**NEWRIVER RETAIL LIMITED**

**PROPOSED RESIDENTIAL DEVELOPMENT, HENBLAS ROAD, WREXHAM**

**TECHNICAL NOTE 02 – RESPONSE TO HIGHWAY AUTHORITY COMMENTS**

**1<sup>ST</sup> DECEMBER 2016**

title  
PROPOSED SITE ACCESS VISION SPLAYS  
AND CAR PARK DIMENSIONS

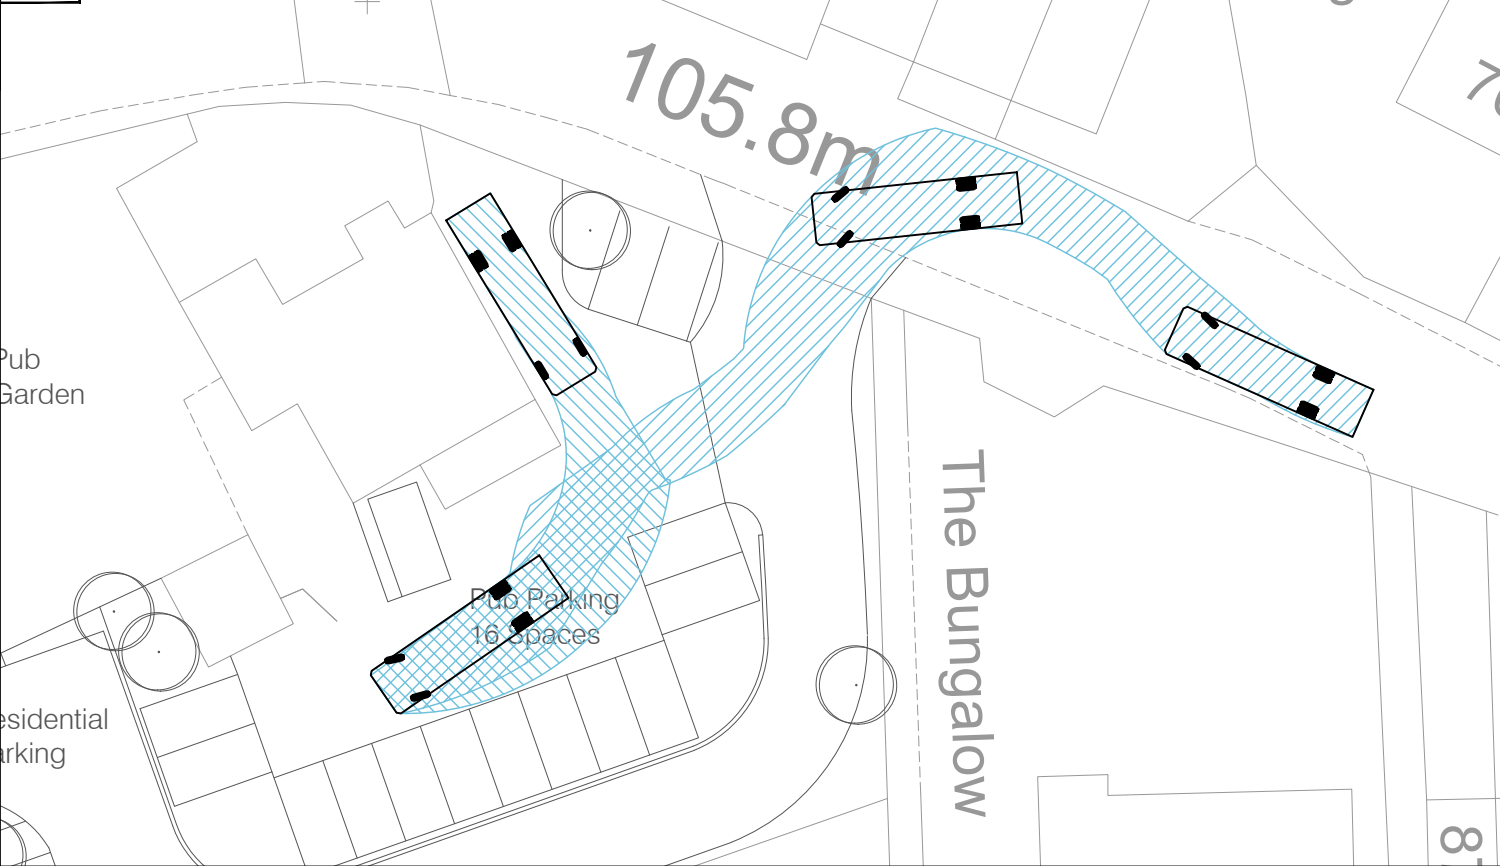
*Demarcate on the plan the length / width of car parking and turning spaces for the car park and the proposed dwelling*

*Demarcate the width of the proposed private drive leading to the three dwellings*

Demonstrate forward visibility on the private road around the bend at the south east corner of the site.

Is the red / blue dividing line between the two sides intended to be a fence; and if so what height?

It is not completely clear what is being requested however the drawing provided at **Appendix 2**, shows a collection of parking bay and manoeuvring area measurements. Should any more be required then these can be provided if requested.

As requested the width of the private driveway has been shown at a number of locations, on the drawing provided at **Appendix 2**.

As requested forward visibility of the private driveway at the bend has been shown on the drawing provided at **Appendix 2**.

It is understood that the fence is proposed to be a 1.8m high close boarded fence, as labelled on the drawing provided at **Appendix 2**.

title  
SWEPT PATH ANALYSIS  
FTA DESIGN HG RIGID VEHICLE

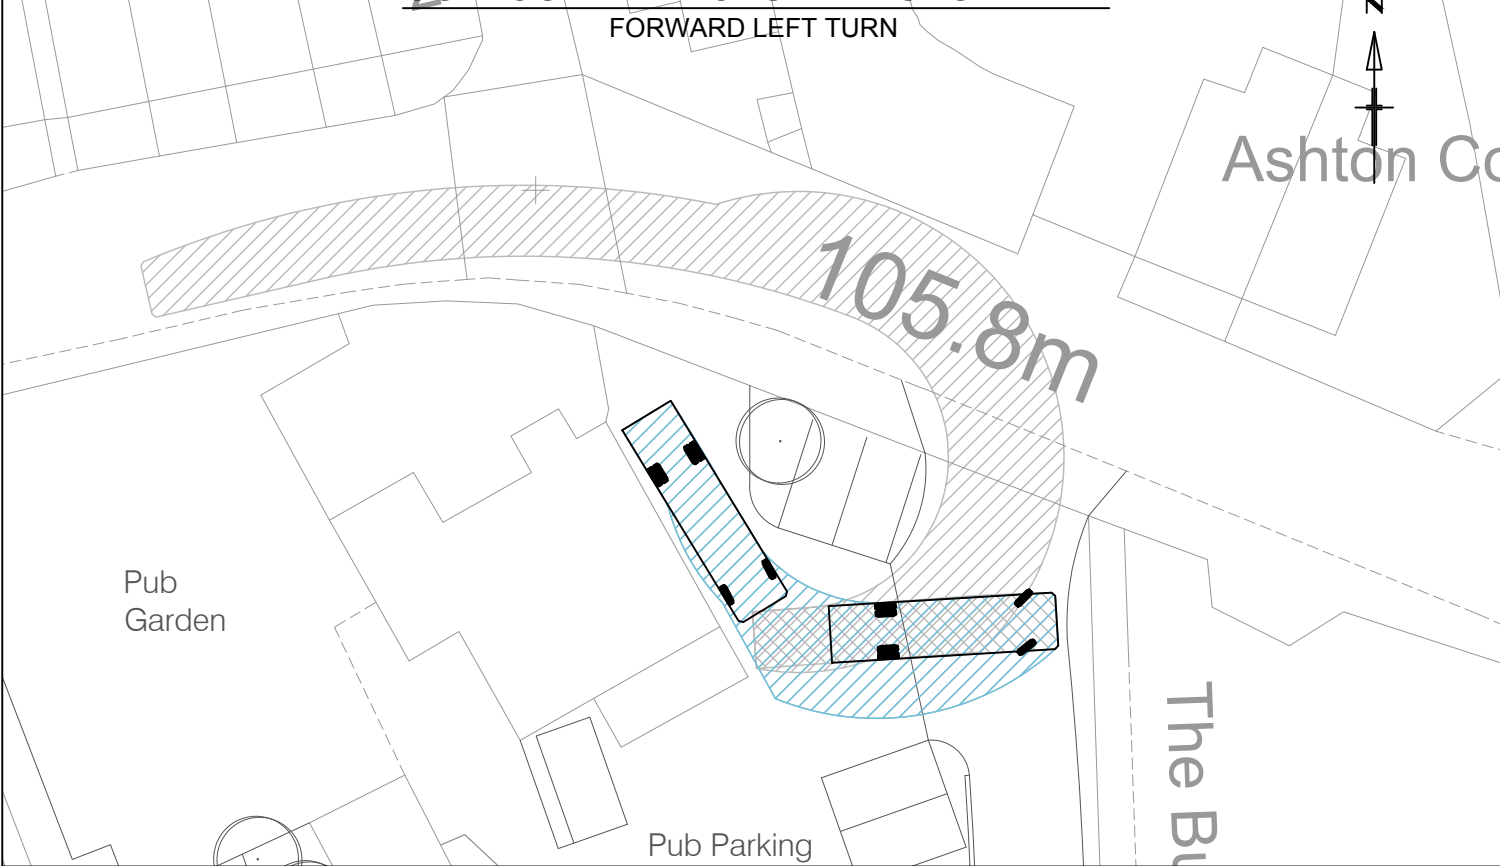
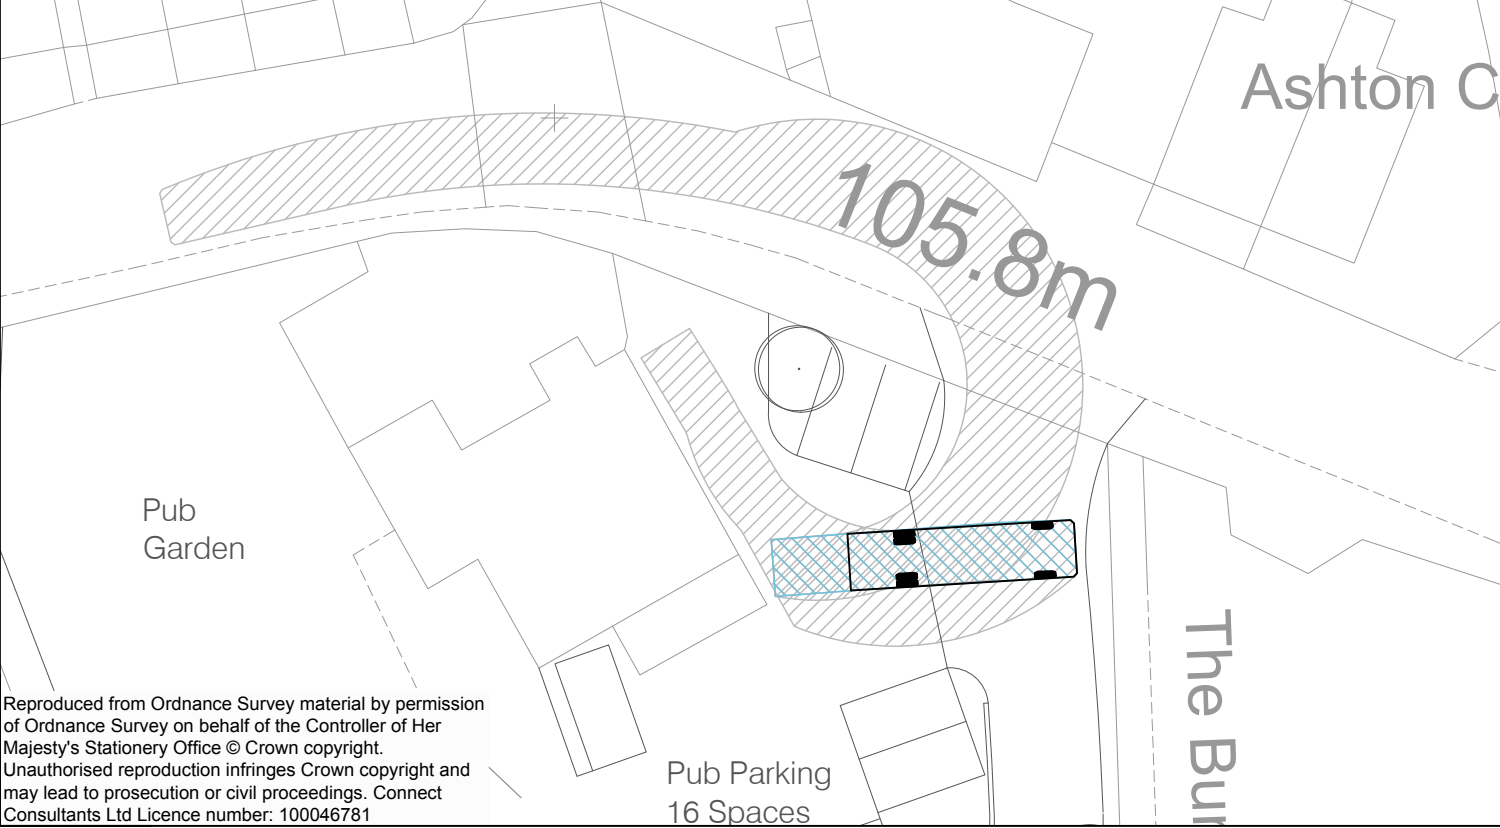
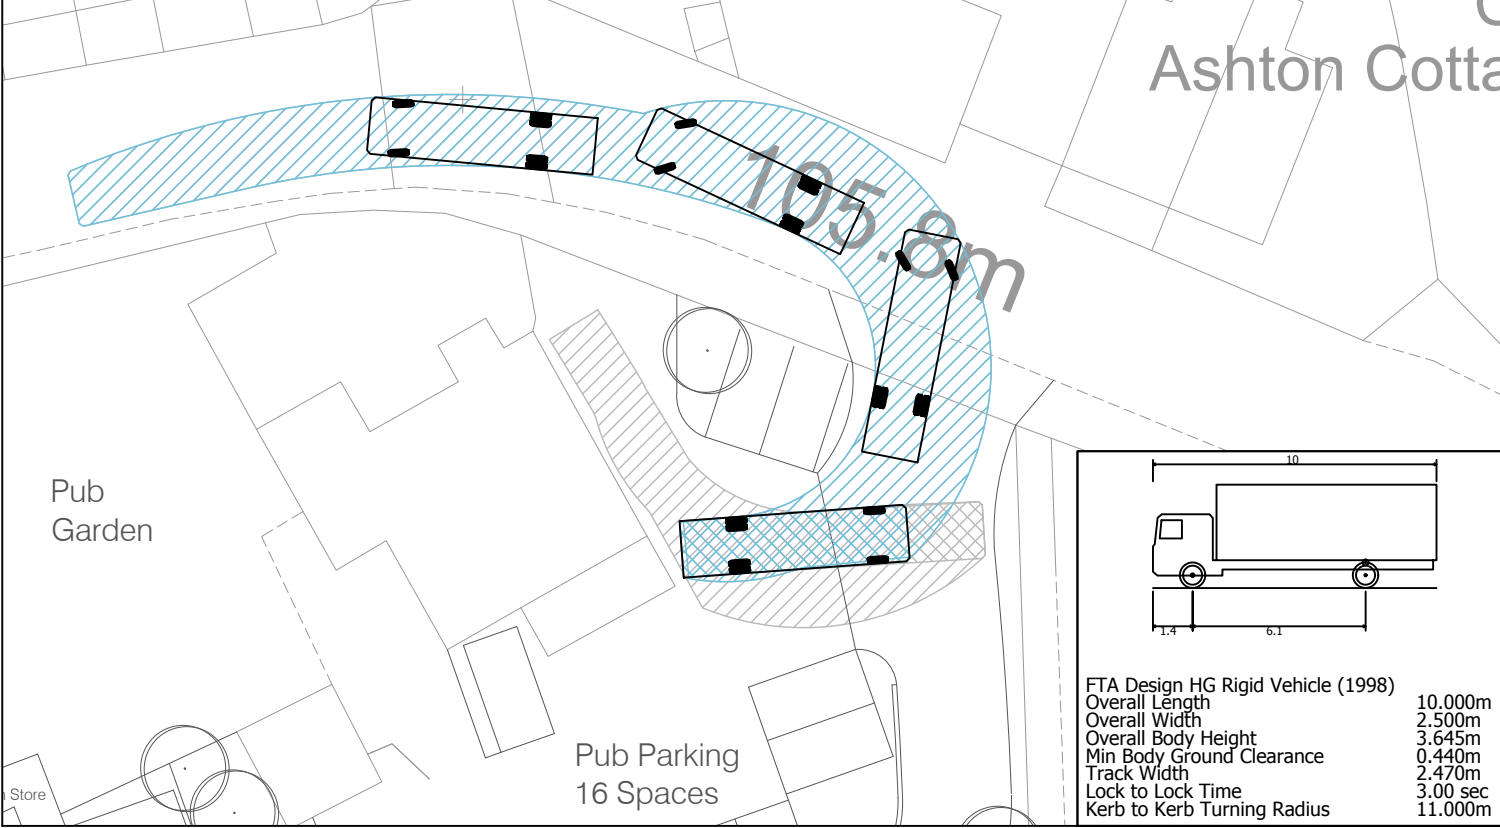
How many forward / reversing movements will it take for dray vehicle to exit the site?

The swept path analysis appears to show that the dray vehicle can access the site if there are no vehicles parked in approximately 5 of the car parking spaces. I presume that this would have to be managed under a construction traffic management plan. However the swept path showing the dray vehicles egressing the site is unclear. Can you ask the applicant to demonstrate how many forward / reversing movements it will take for the dray vehicle to exit the pub car park.

The Autotrack software indicates that a 10m rigid vehicle will require 3 movements (2 forward and 1 reverse) to exit the site following servicing. A drawing showing swept path analysis broken down by manoeuvre segment is provided at **Appendix 3**.
